# NORTH TEXAS MUNICIPAL WATER DISTRICT

## LAKE SIDE INTERCEPTOR REPLACEMENT

PROJECT NO. SRWWPCF 07-1(102)

### CONFORMED SET

**PLAN AND PROFILE**  
 STA. 54+00 TO STA. 59+00

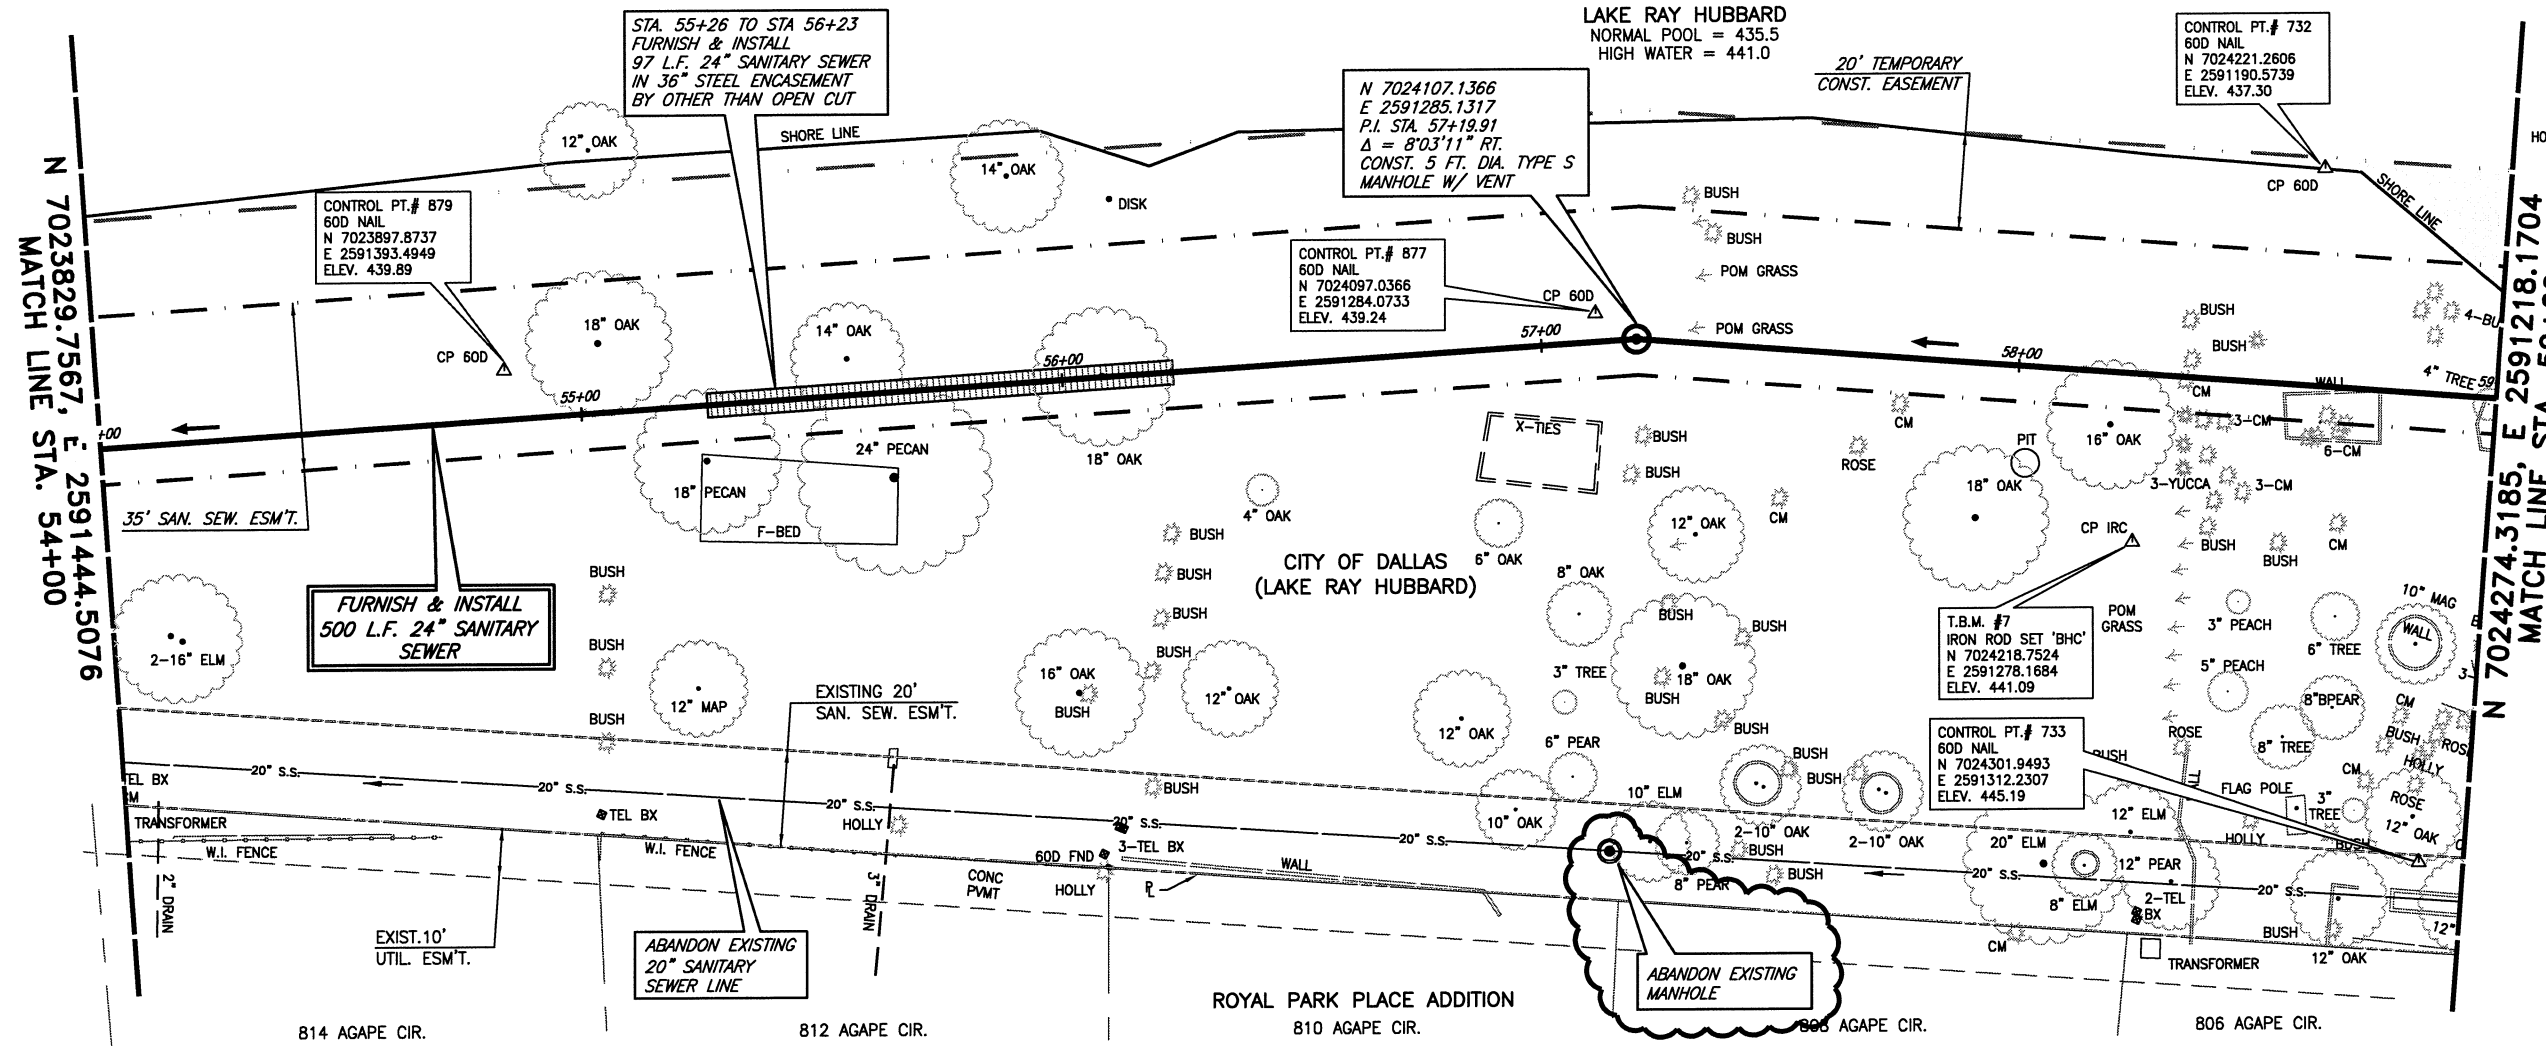
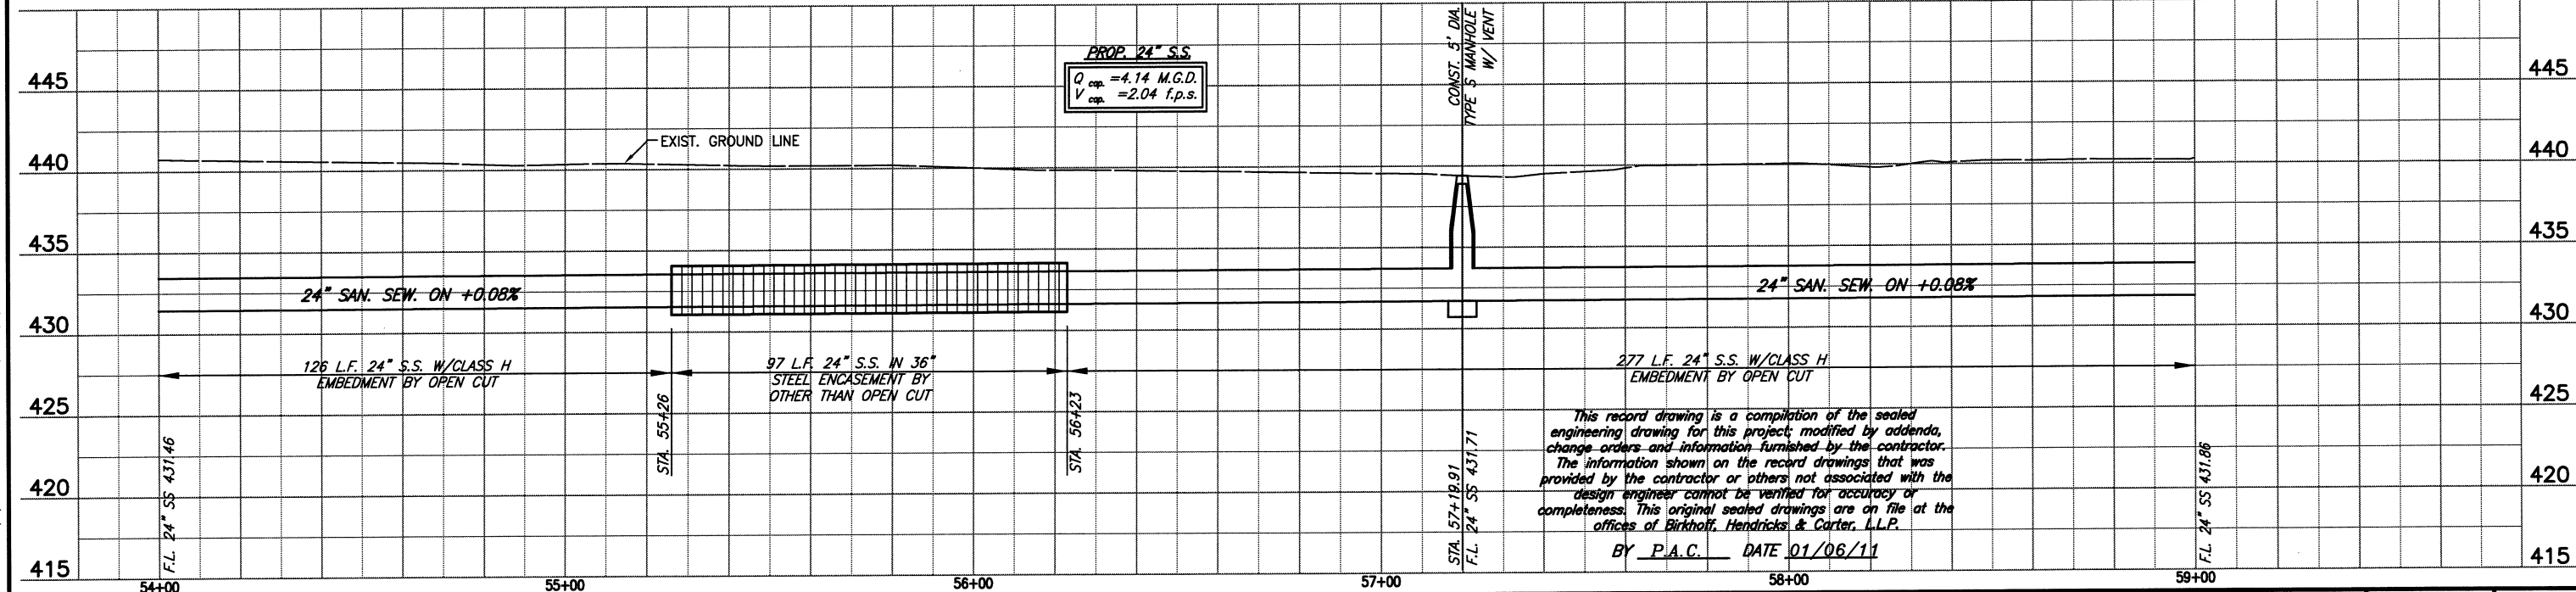
CHANGE ORDER NO.1 2/12/09 - REVISED BORE LOCATIONS & ENCASEMENT
FIELD CHANGE NO.4 6/29/09 - REVISED VERTICAL ALIGNMENT

**PLAN AND PROFILE**  
STA. 59+00 TO STA. 64+00

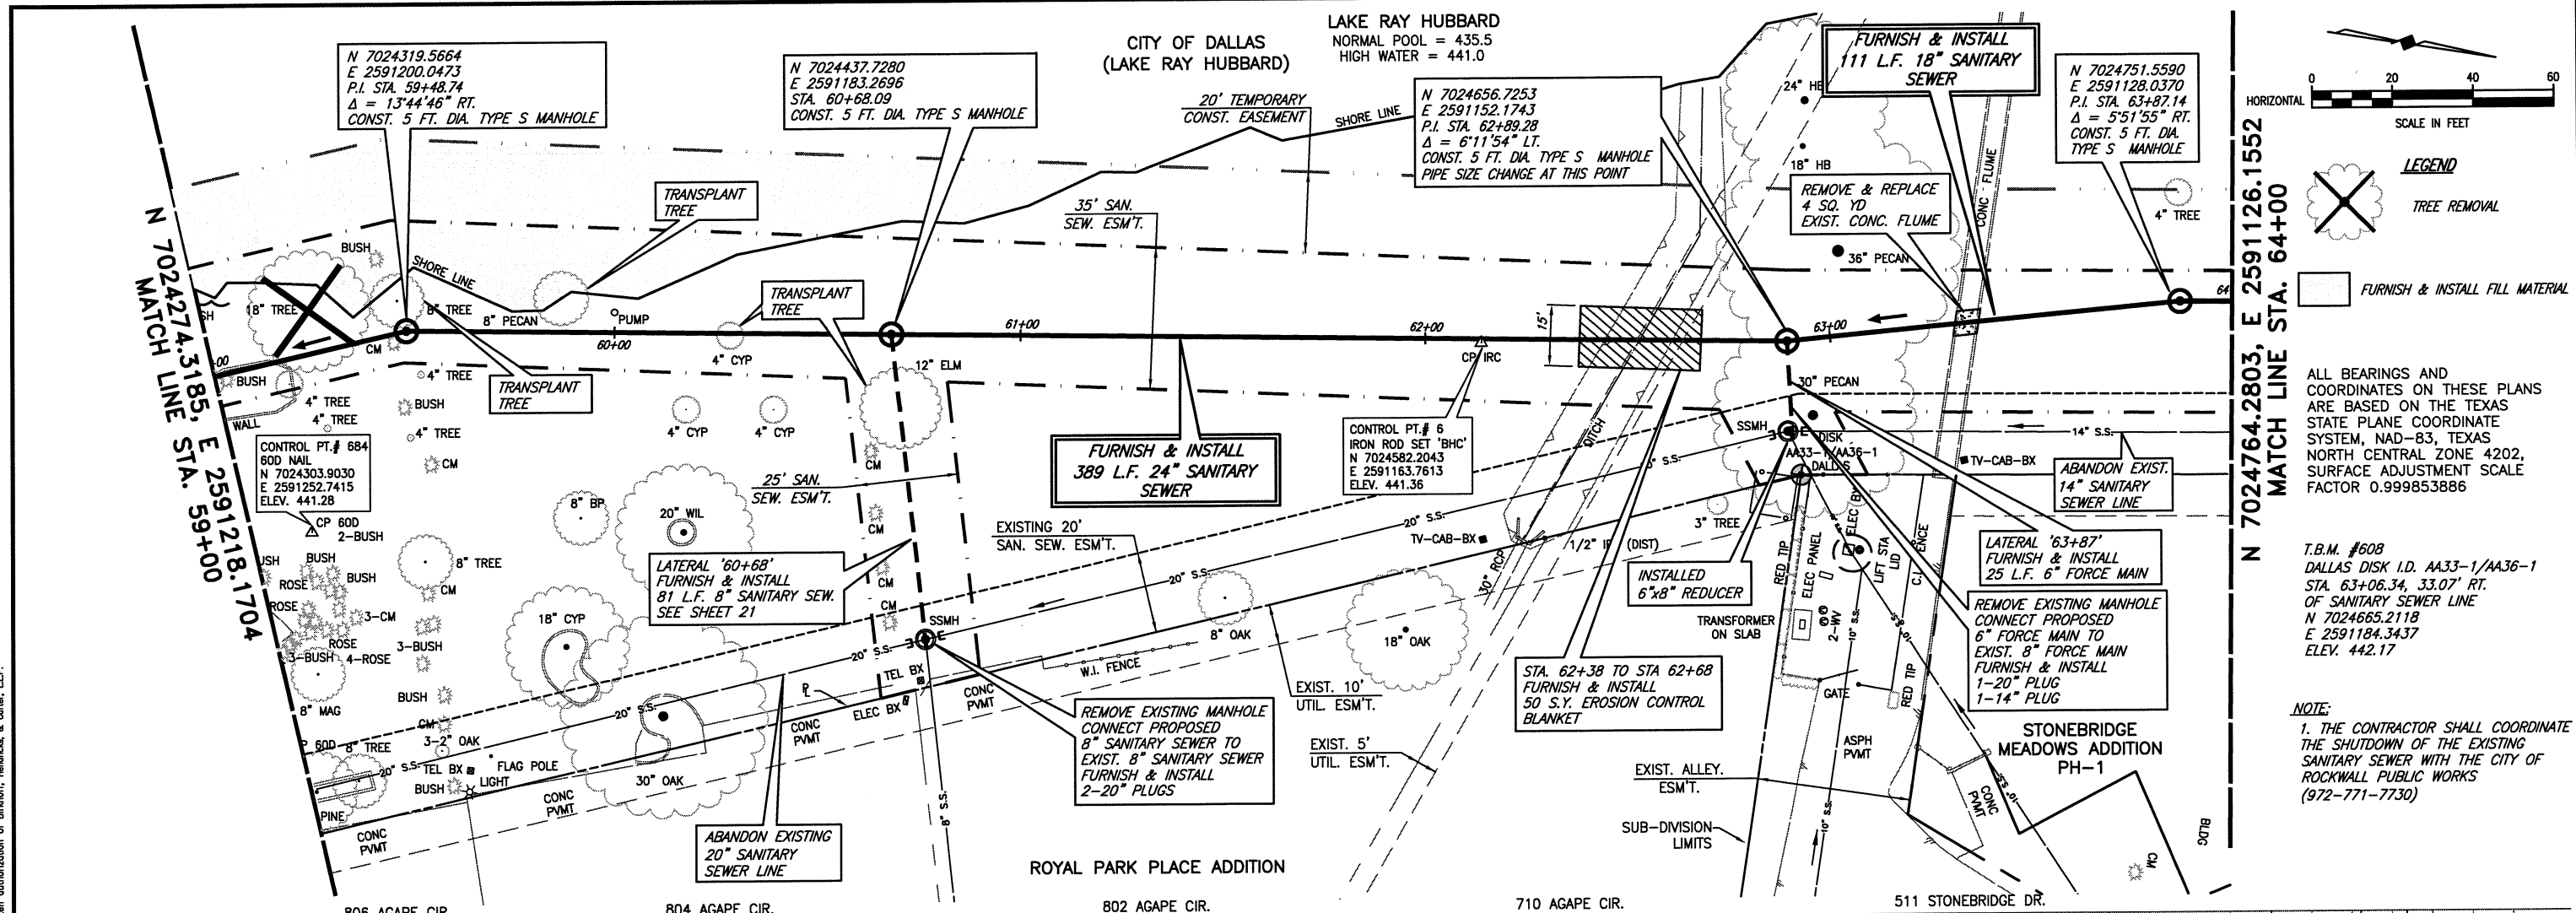
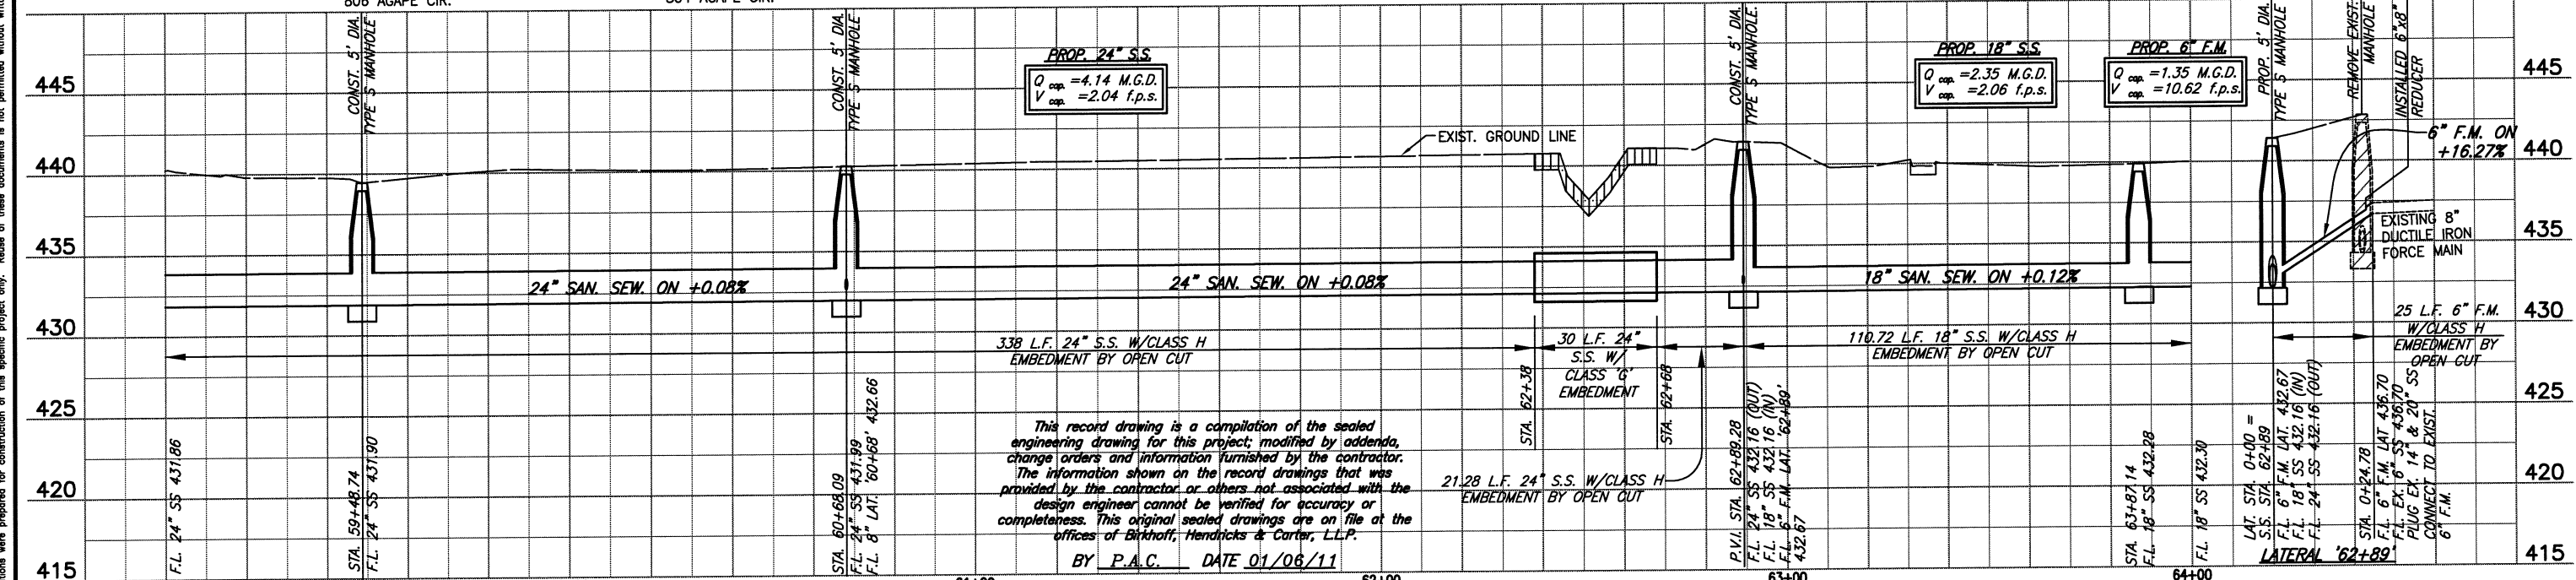
FIELD CHANGE NO.2 2/12/09 - REVISED TREE REMOVAL LOCATIONS
CHANGE ORDER NO.1 2/12/09 - REVISED BORE LOCATIONS & ENCASEMENT
FIELD CHANGE NO.4 6/29/09 - REVISED VERTICAL ALIGNMENT
